**Flexible Resource Adequacy Criteria and Must-Offer Obligation
Fifth Revised Straw Proposal Stakeholder Comments**

Figure 2: 100 MW Peaker vs. 100 MW Peaker + 25 MW 15-Minute Energy Storage

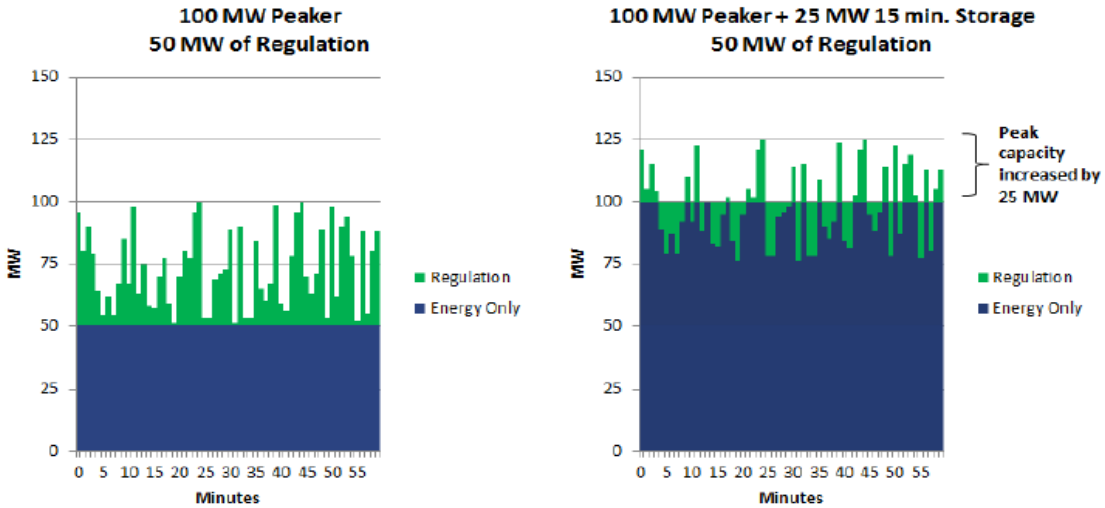
As is shown above in Figure 2, the REM resource demonstrably contributes to peak capacity at its full 15-minute rating.

The ISO appreciates CESA’s desire to include REM resources in the category 1 flexible capacity. However, the ISO believes that REM only resources appropriately belong in the super-peak category. The regulation that REM resources provide is designed to address a specific need for regulation, not load following or longer ramps. As such, the ISO believes that it is not appropriate to include a resource that is not able to address flexible capacity needs beyond the regulation. While CESA asserts that REM resources help during peaks, even CESA’s figure 1 shows that the REM resource is providing regulation during the peak ramping events, not energy or ramping services. Additionally, the representation in figures 2 and 3 are not accurate. The ISO would dispatch to load and regulation up and down would be procured to fill in the fluctuations.

Figure 3: 2x100 MW Peaker vs. 2x100 MW Peaker + 25 MW of 15 Minute Storage

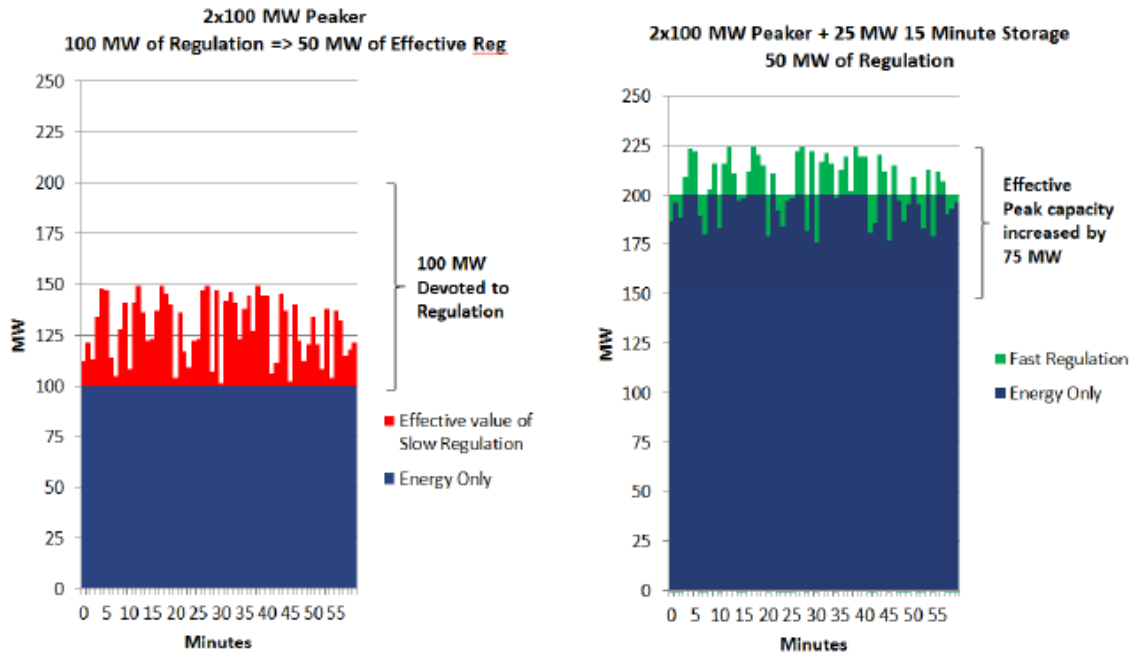
Additionally, because energy storage resources have been found to supplant the regulation capacity of at least two slower regulating generators, the EFC of a fast responding storage resource is in fact more than double its 15-minute capacity, in comparison with traditional resources. The effect of this fast response is shown below in Figure 3.

Figure 4: Regulation Energy Storage Reduction in Flexible Need

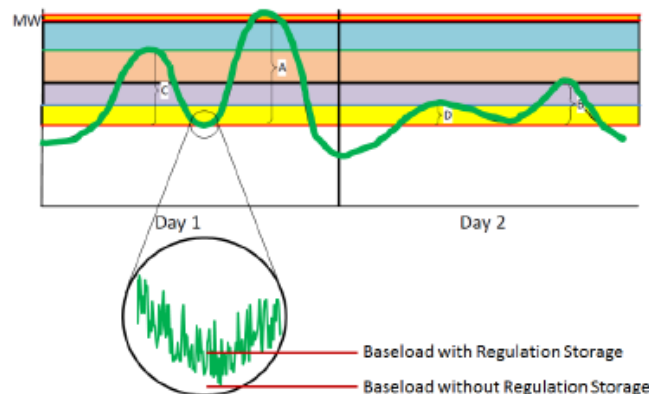
Bi-directional regulating storage resources *decrease* the need for flexibility at the low points in the net load curve shown below in Figure 4:

CESA recommends that the EFC of a 15-minute energy storage resource should be calculated according to its actual contribution to the 3-hour ramp. Effective Flexible Capacity (“EFC”) should not be arbitrarily limited to the NQC, as is in effect proposed in the Proposal. CESA urges the CAISO to set the FRAC-MOO rules according to its real grid operation needs and its own market rules, rather than conform to a NQC rating system inconsistent with grid operations and a bundling principal that is unworkable in practice.

The charging cycle of storage may be able to provide flexibility, but the concept needs additional analysis. Further evaluation should be made of the timing of the peak and the trough of the net load, how they relate to the three-hour net load ramp, the characteristics of storage devices, and how they will be used by the ISO market optimization to reduce the net load ramp.

Figure 5

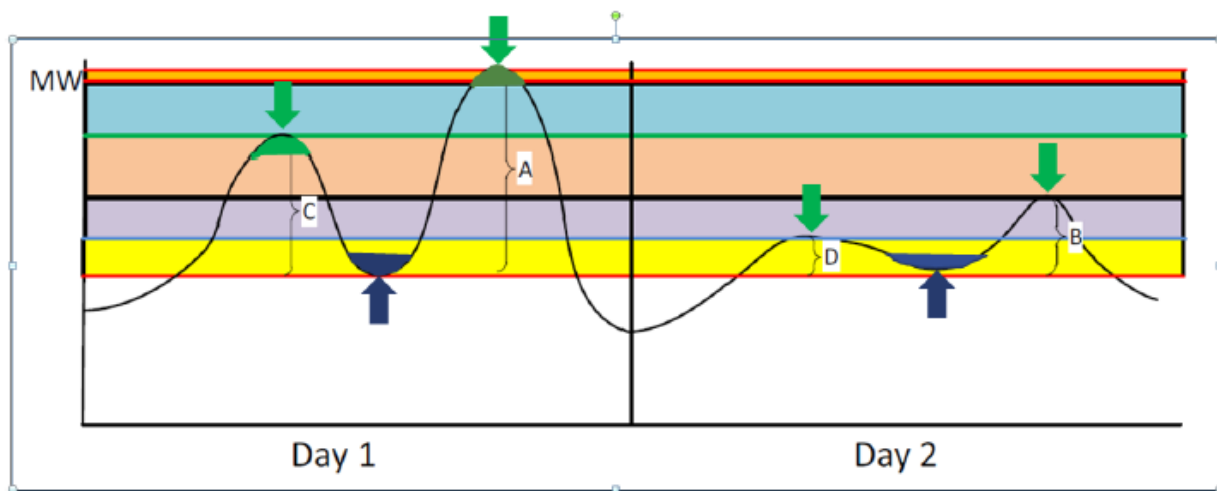
Significant progress has been made toward the development of counting methodologies that assure comparable treatment of capabilities in the Proposal. However, many energy storage resources have the capability to charge and discharge in a highly dispatchable manner, and the counting methodology for the charging dispatch is still unclear. As shown below in Figure 5, long duration bi-directional energy storage can provide flexible benefits during charging and discharging.

Energy storage resources that can provide dispatchable charging during times of low net load provide a flexibility benefit to the grid, because they decrease the overall ramp. According to the structure of the Proposal, dispatchable charging is not counted as flexible capacity. Rather, the Proposal treats dispatchable charging as a reduction in the need for flexible capacity.

The ISO has provided additional clarity on the counting provisions for storage resources that elect the full flexible capacity option. The ISO proposal treats the output of energy storage resources more consistently with conventional resources by allowing for a ramp rate rather than assuming a constant output across all hours. Additionally, it provides a clear first step for accounting for the flexible capacity benefits of energy storage resources. The ISO believes the charging portions of energy storage resources can provide flexible capacity. While the ISO's proposed methodology does not account for the charging portion, it provides a starting point that easily facilitates improvement without starting over.

Further, while the charging cycle of some storage resource may be able to provide flexibility, the concept needs additional analysis. Further evaluation should be made of the timing of the peak
